INDIAN POINT NUCLEAR GENERATING UNIT NO. 2

Amendment No. 78
License No. DPR-26

ATTACHMENT TO LICENSE AMENDMENT NO. 78

SAFETY EVALUATION BY THE OFFICE OF NUCLEAR REACTOR REGULATION
RELATED TO AMENDMENT NO. 78 TO FACILITY OPERATING LICENSE NO. DPR-26

Figure 3.1-1

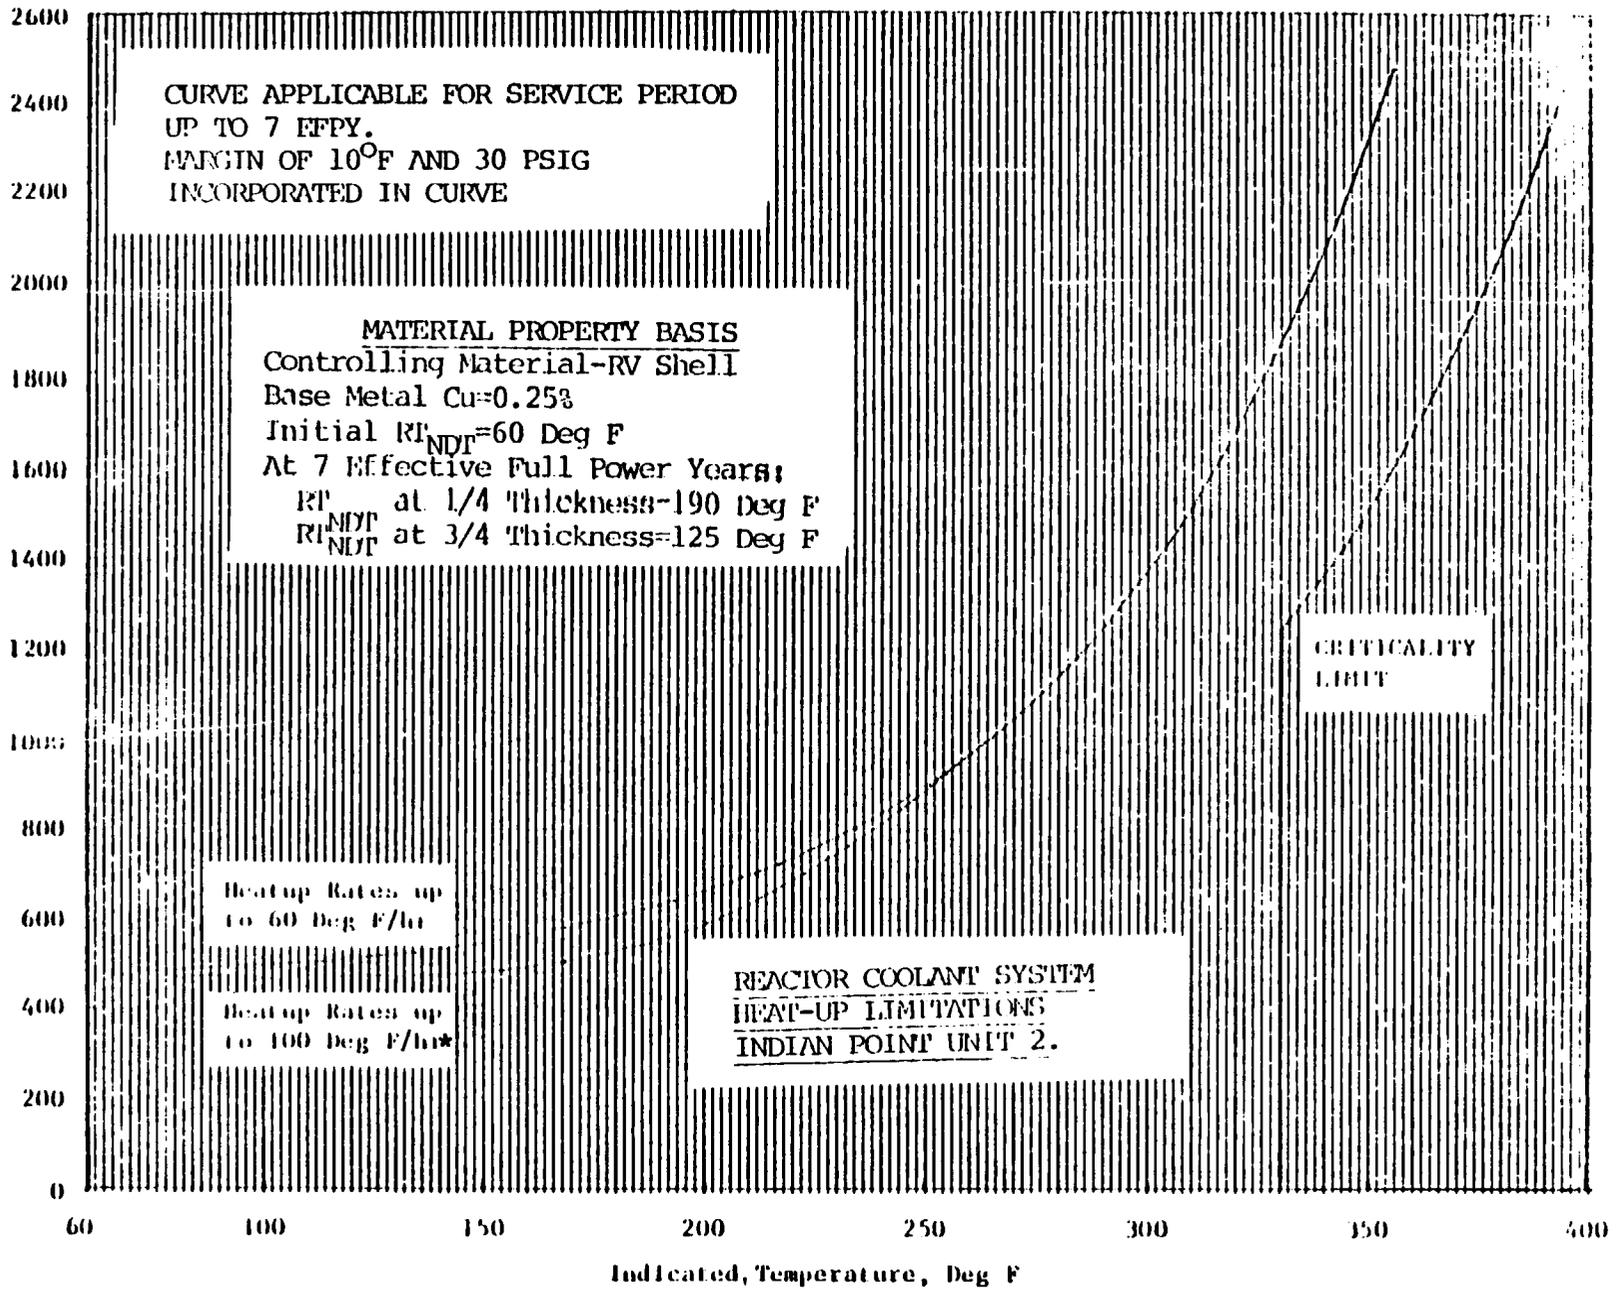
*Pending NRC approval of 100°F/hr heat up curve, reactor coolant system heat up rate shall not exceed 60°F/hr.

Our review indicates that all the limit curves, except for the 100°F/hr. heat up curves in the IP-2 proposed Technical Specifications meet the requirements of our regulations and are acceptable for seven effective full power years (EPFY). Our calculations indicate that the licensee must shift the 100°F/hr heat up curve 29°F to meet our regulatory requirements.

The difference in the 100°F per hour heat up curves calculated by IP-2 and the staff appears to result from a difference in the calculated thermal stress intensity factor and the metal/coolant water temperature relationship. Our evaluation of the information submitted by the licensee indicates that the thermal stress intensity factor and the metal/coolant water temperature relationship used by the applicant in the calculation of the 100°F/hr heat curves are applicable for 60°F/hr heat up, but not 100°F/hr heat up. Accordingly, the applicant's amendment request with respect to the 100°F per hour curve has been deferred and is not approved by this amendment action.

*Pending NRC approval of 100°F/hr heat up curves, reactor coolant system heat up rate shall not exceed 60°F/hr.

Figure 3.1-2

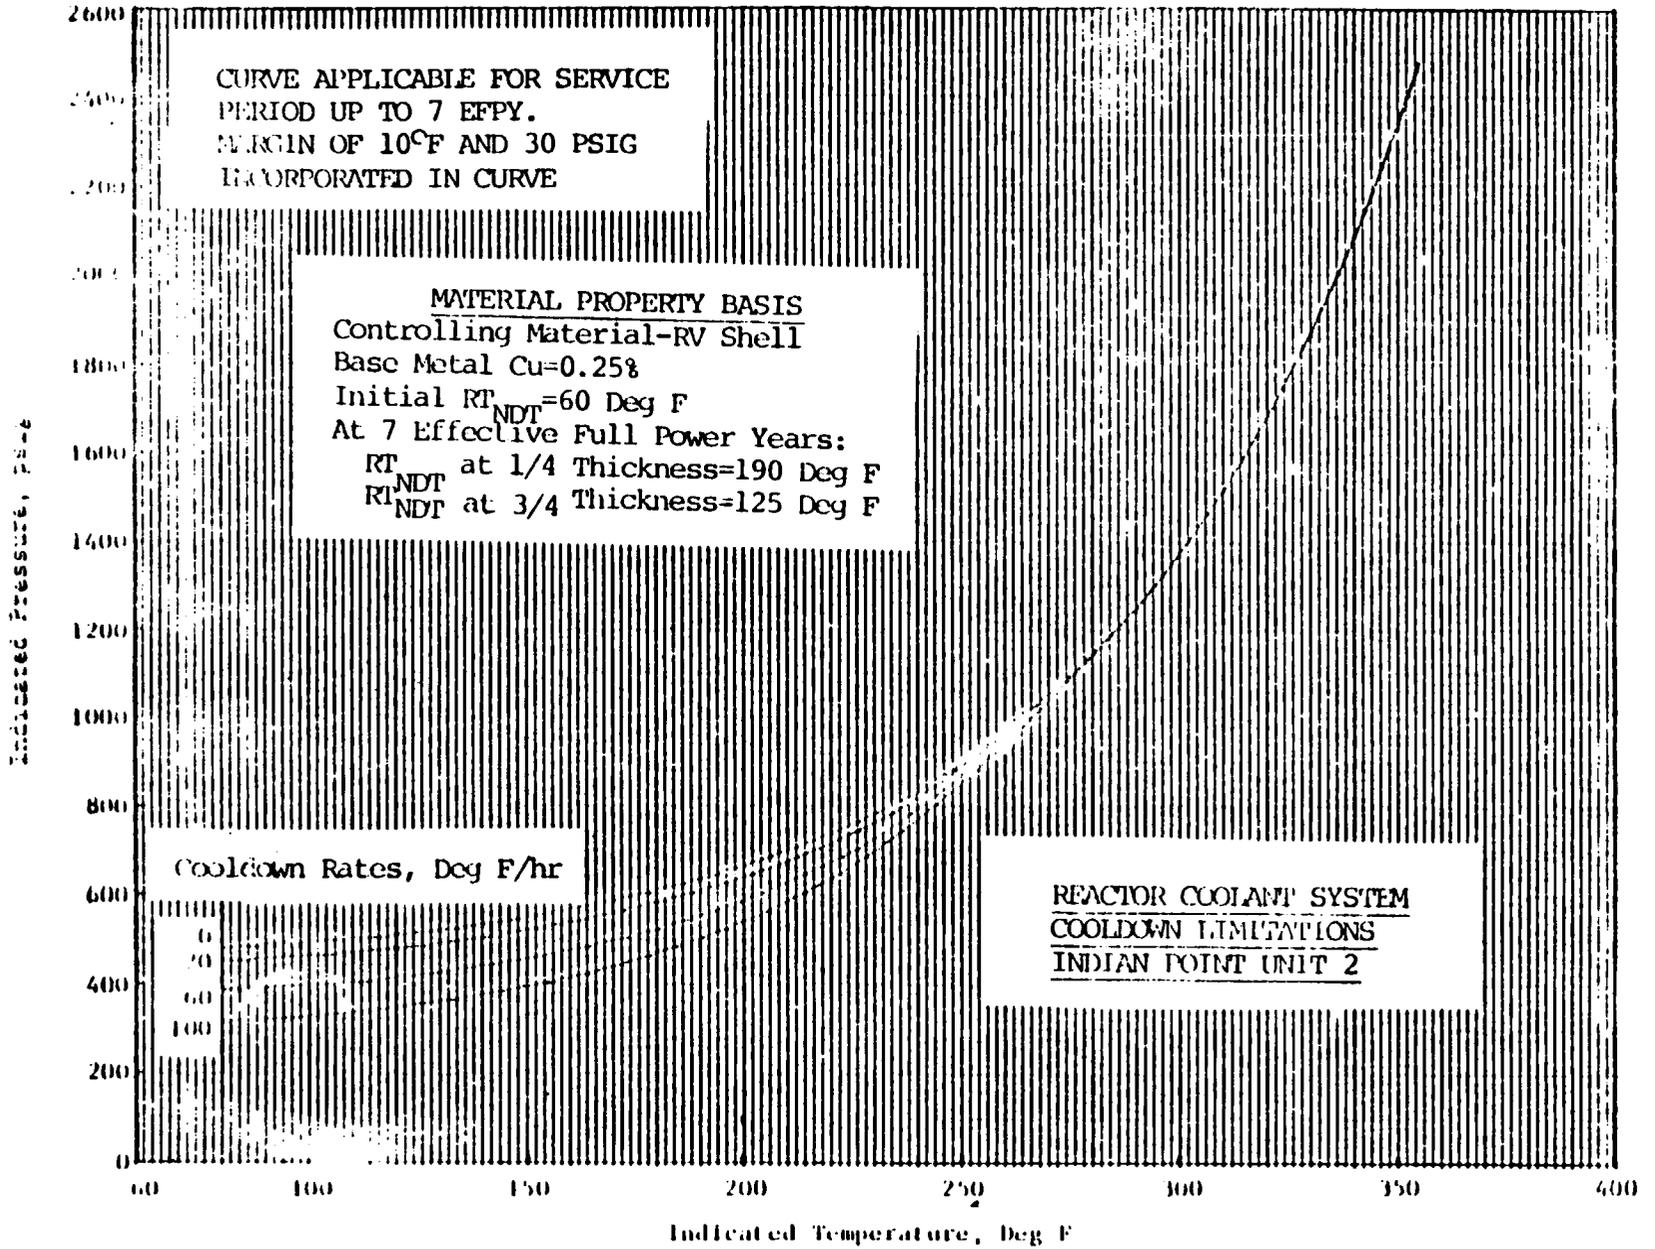
Because operation control is on coolant temperature, and cooldown rate may vary during the cooldown transient, the limit curves shown in Figure 3.1-2 represent a composite curve consisting of the more conservative values calculated for steady state and the specific cooling rate shown.

Figure 4.3-1

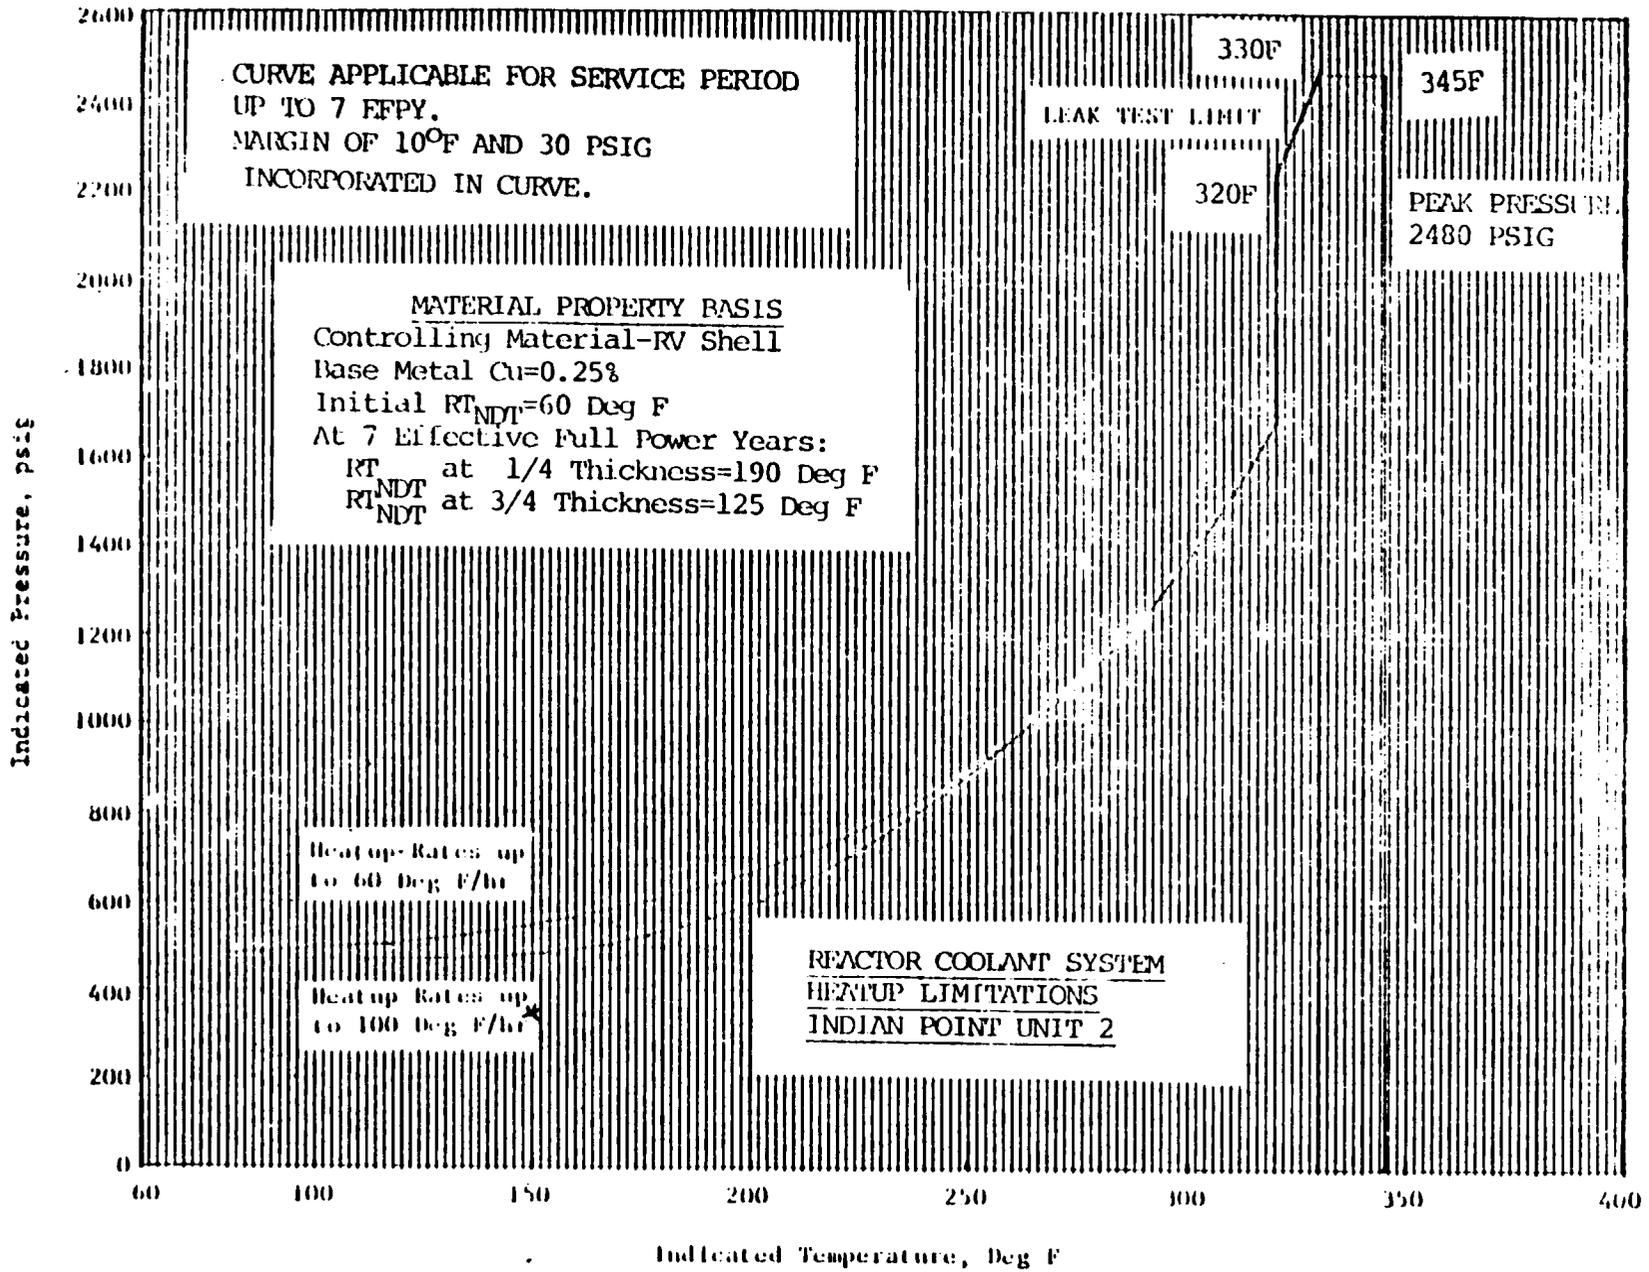
For the first seven (7) effective full-power years, it is predicted that the highest RT_{NDT} in the core region taken at the 1/4 thickness will be 190°F. The minimum inservice leak test temperature requirements for periods up to seven (7) effective full-power years are shown on Figure 4.3-1.

The heatup limits specified on the heatup curve, Figure 4.3-1, must not be exceeded while the reactor coolant is being heated to the inservice leak test temperature. For cooldown from the leak test temperature, the limitations of Figure 3.1-2 must not be exceeded. Figures 4.3-1 and 3.1-2 are recalculated periodically, using methods discussed in WCAP-7924A and results of surveillance specimen testing, as covered in WCAP-7323.

*Pending NRC approval of 100°F/hr heat up curve, reactor coolant system heat up rate shall not exceed 60°F.
